YUKON ENERGY CORPORATION

**MINTO MINE PPA APPLICATION
INTERROGATORY RESPONSES**

March 8, 2007

Map 3 Segment 2.1 McGregor Creek to Minto Landing
Map 4 Segment 2.2 Minto Landing to Lhutsaw Wetlands

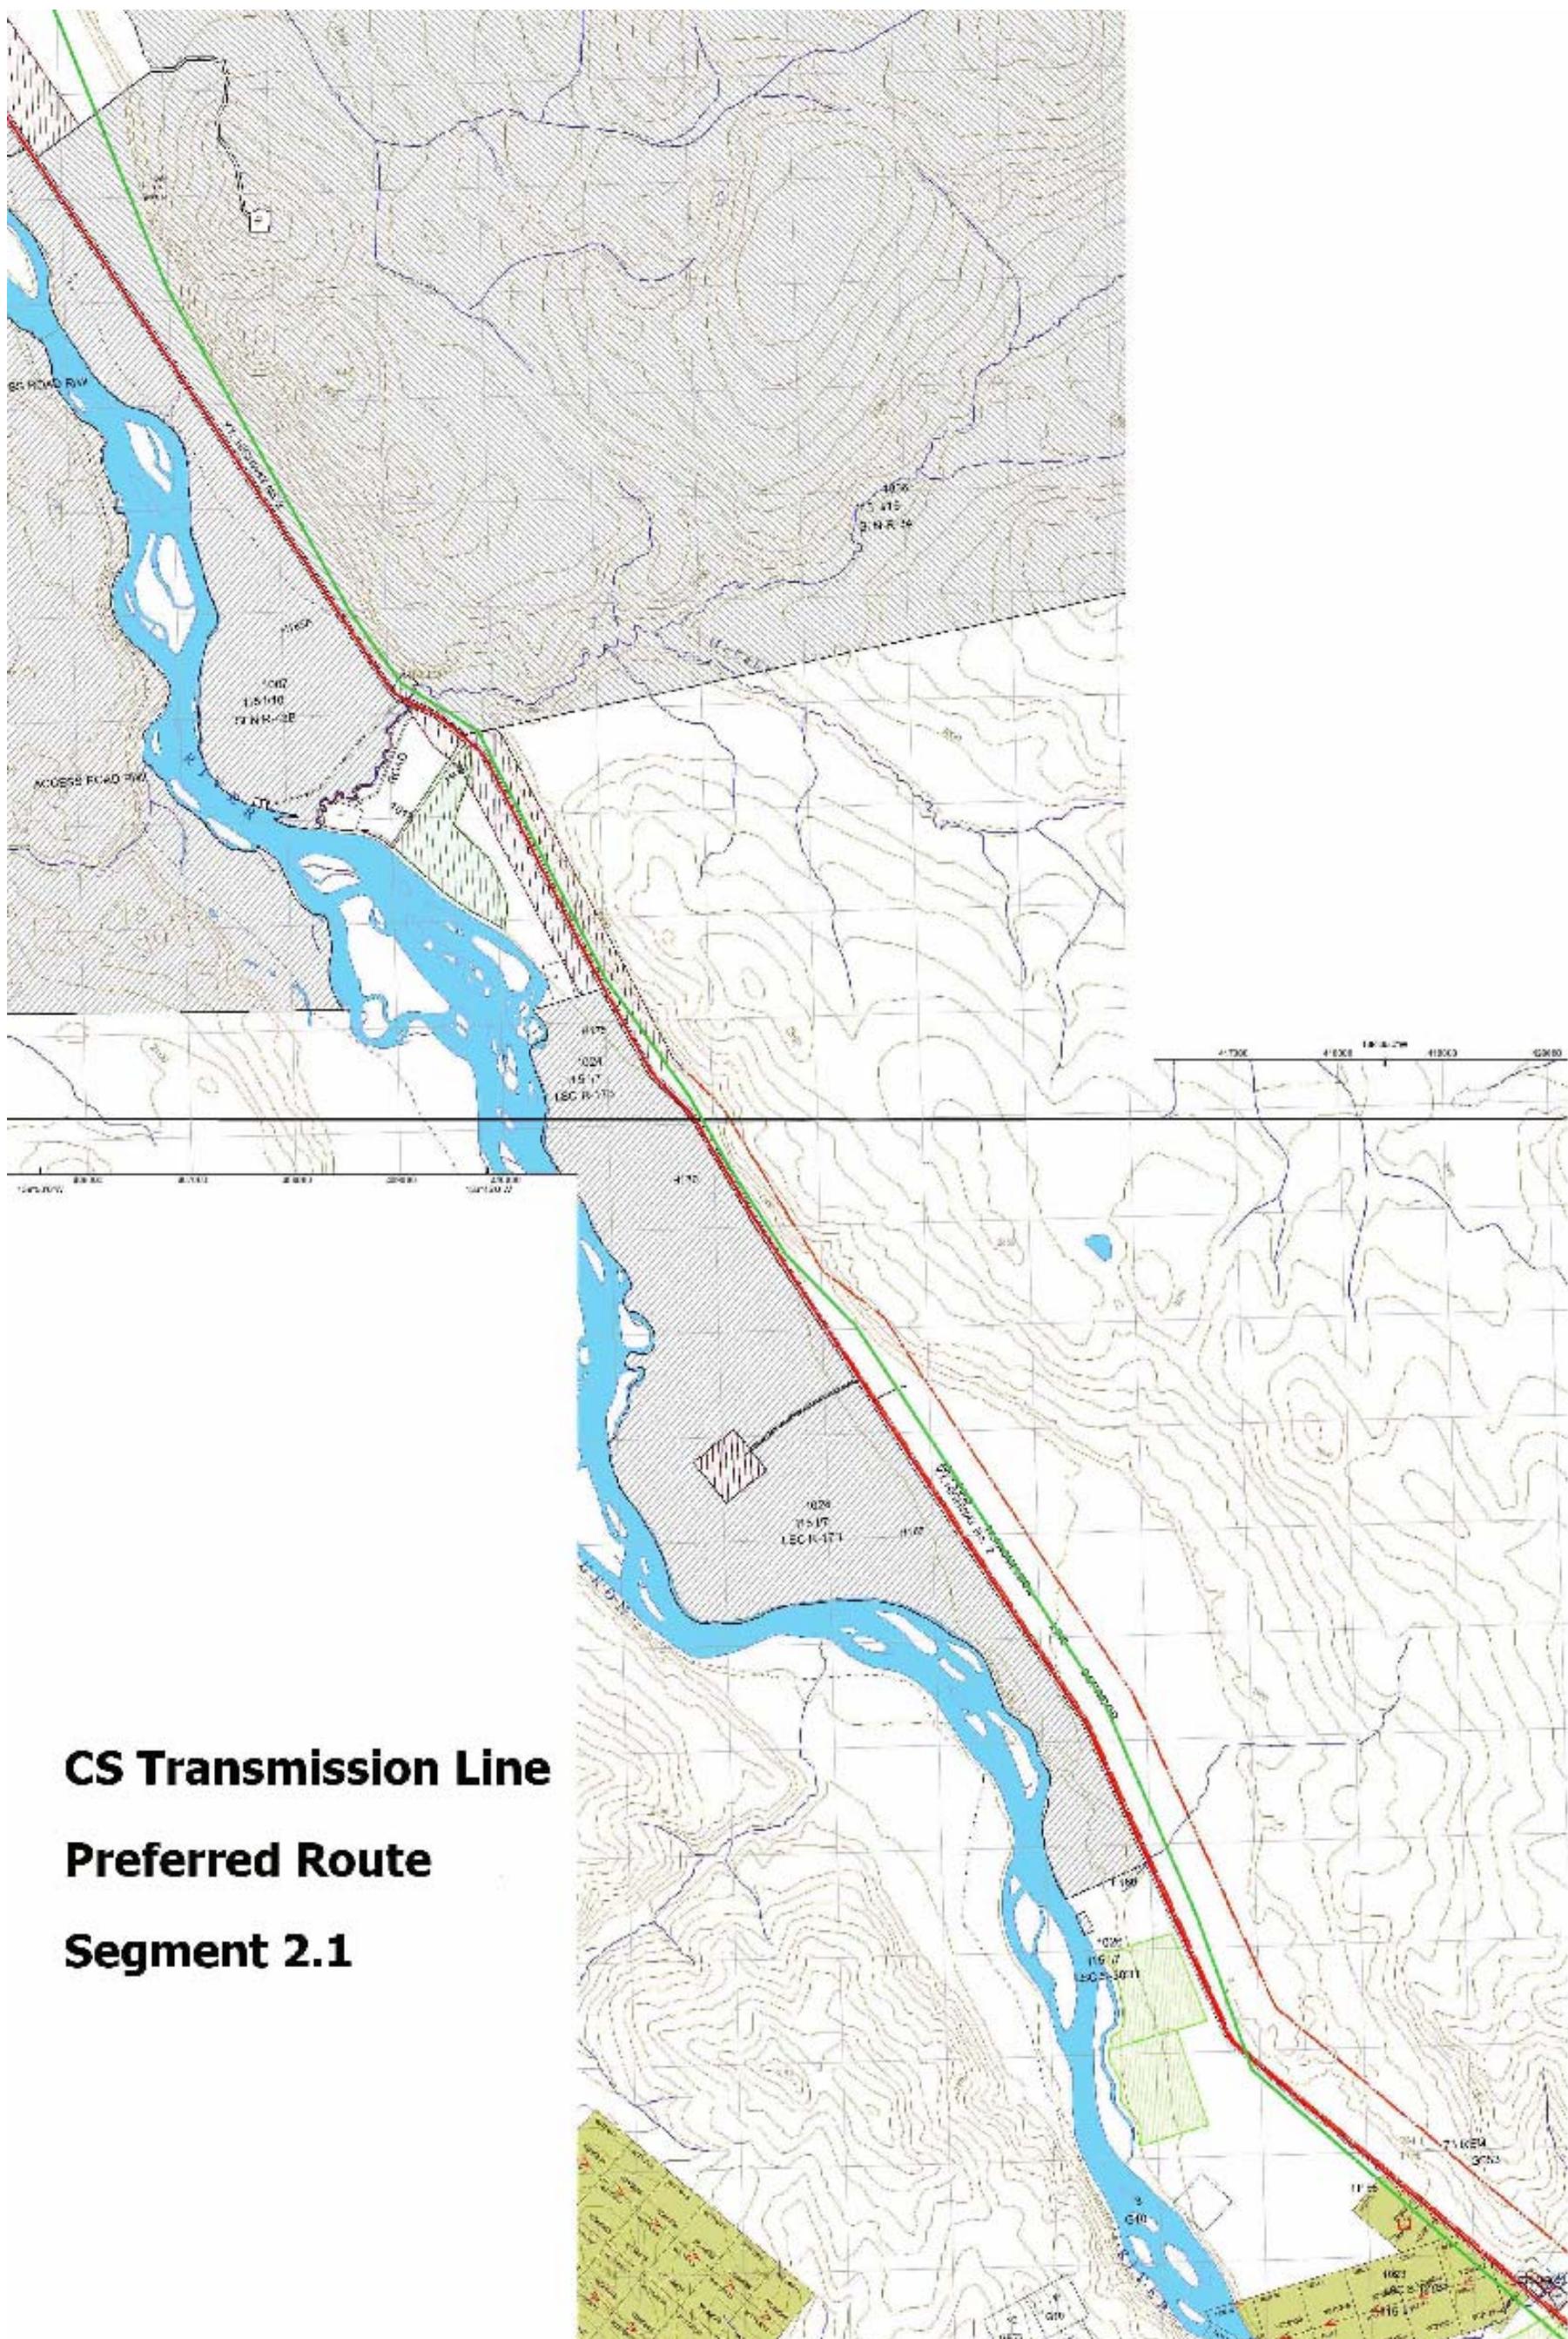
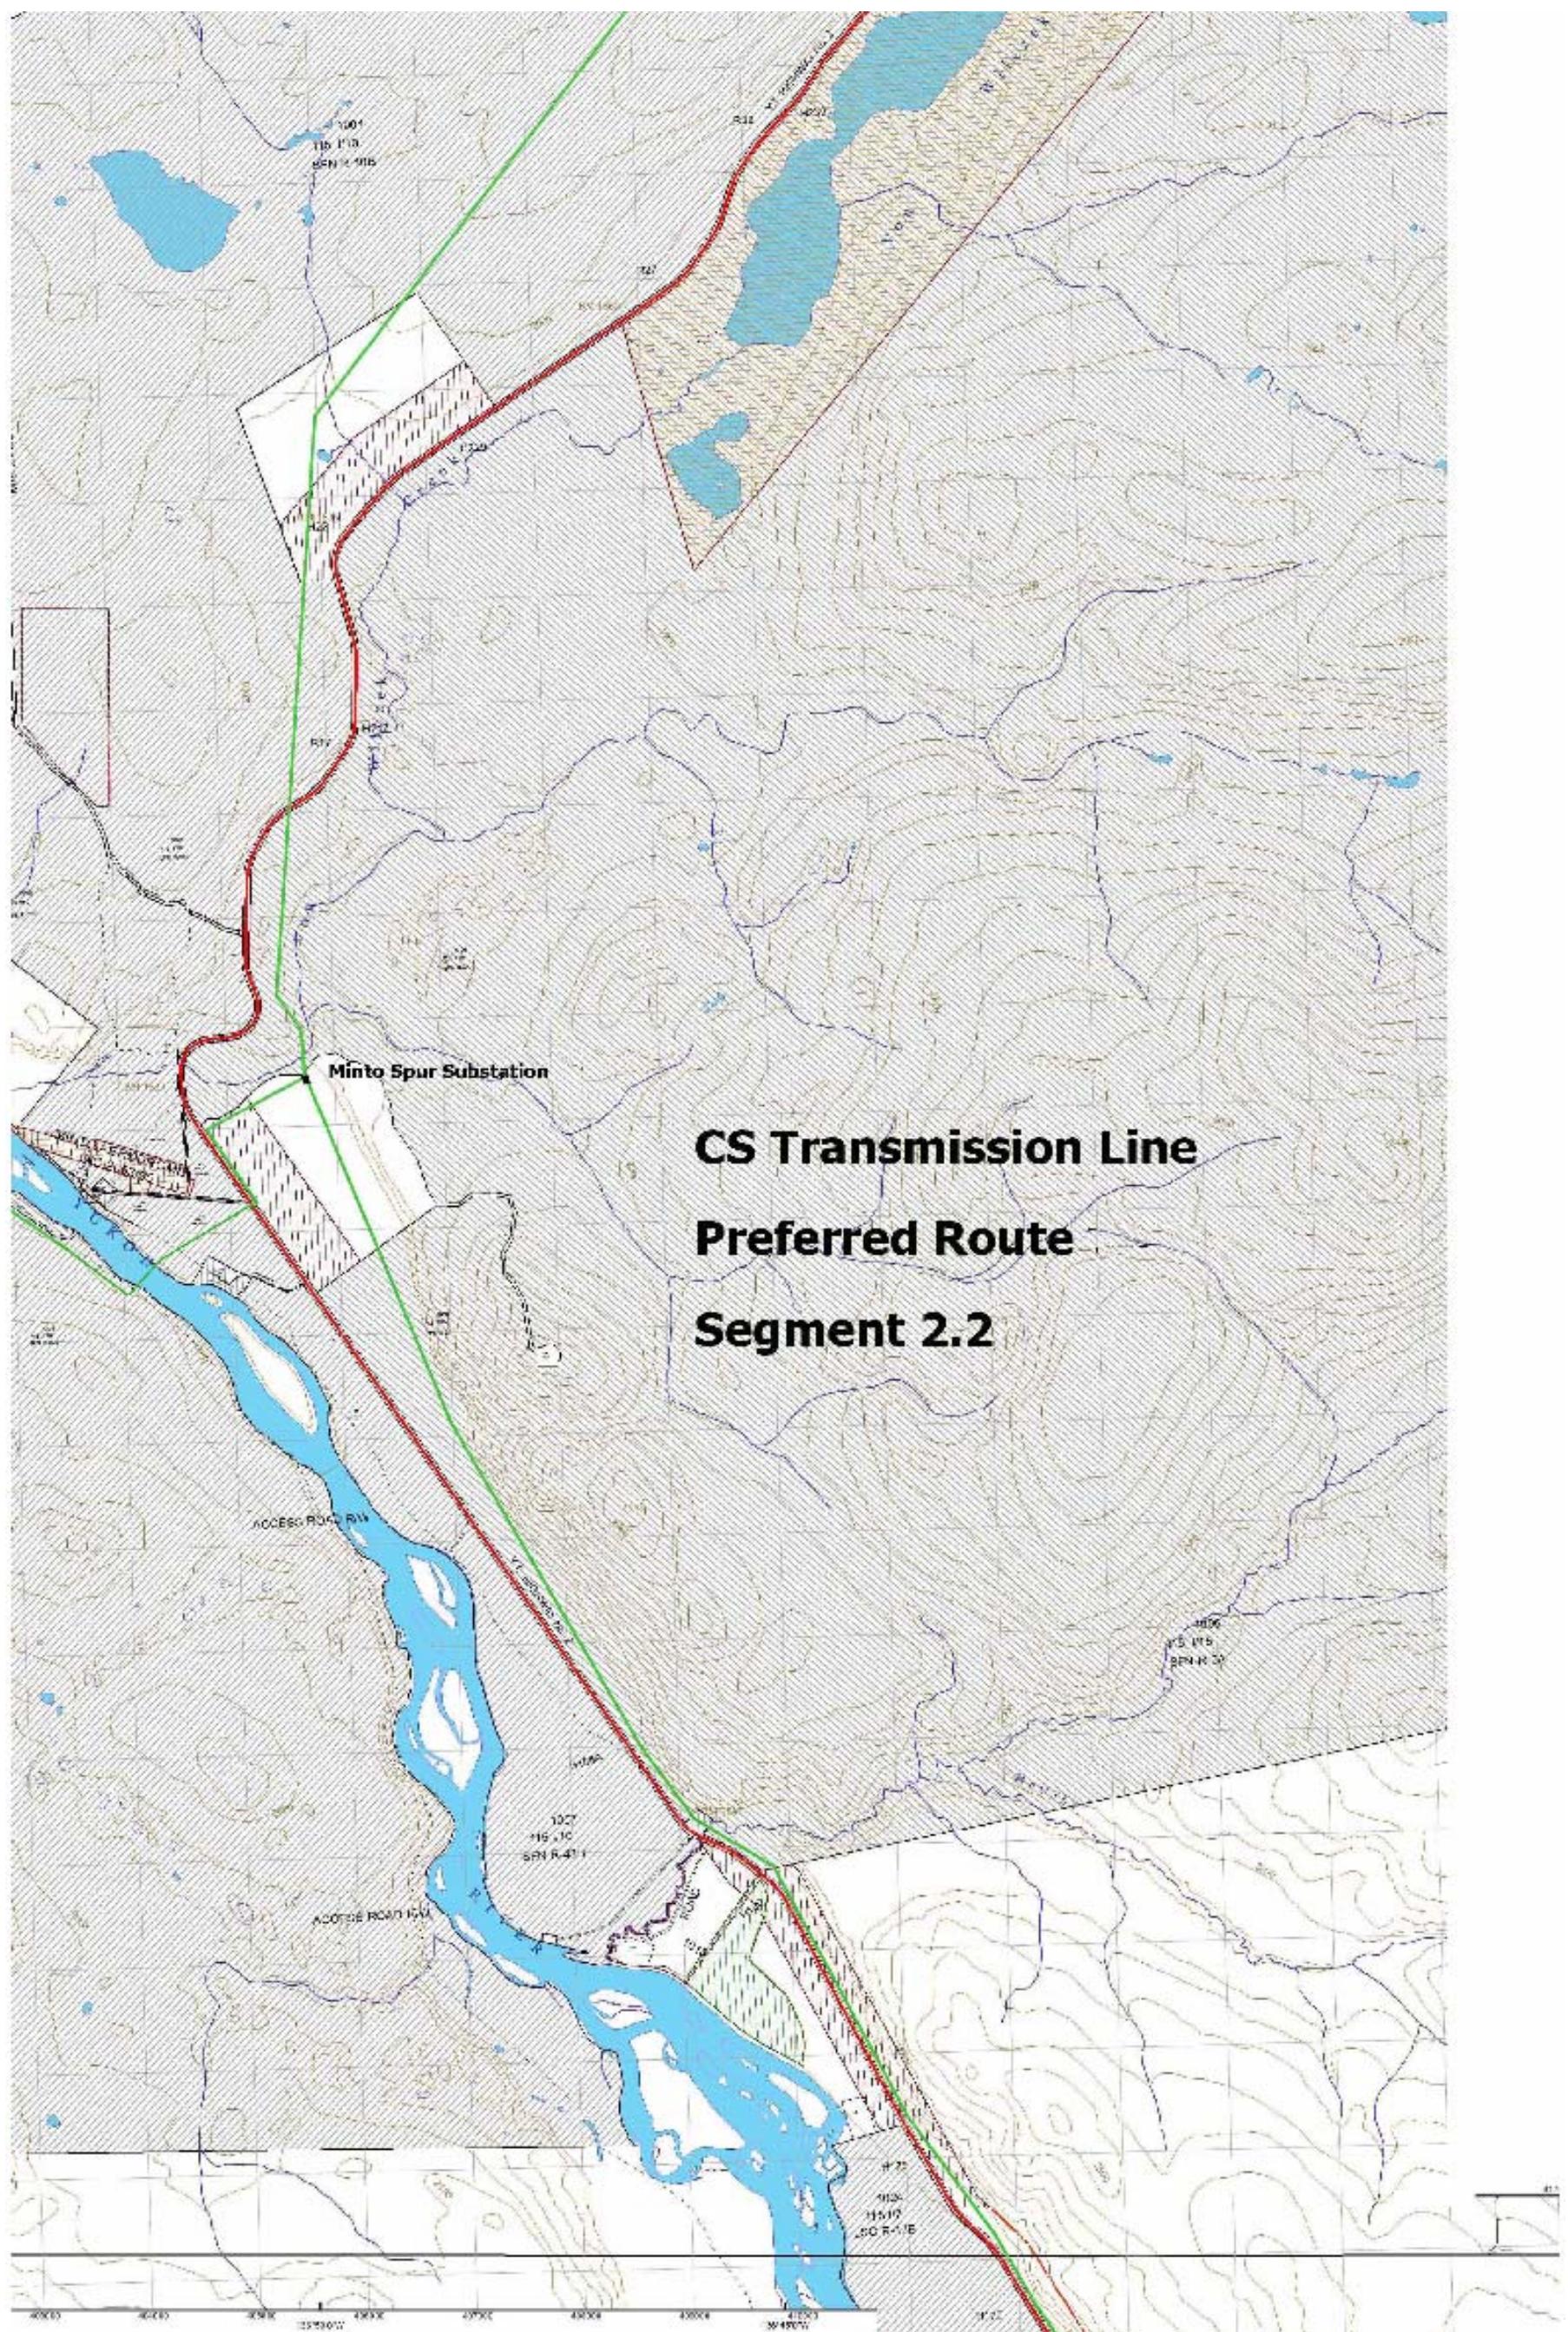
5 1. Please reproduce all the maps of SCHEDULE A & B on 11"x17" at a suitable
6 scale so that they can be seen by the naked eye.

10 SCHEDULE A & B are provided on 11" x 17" sheets in PWP-YEC-1-29 Attachment 1.
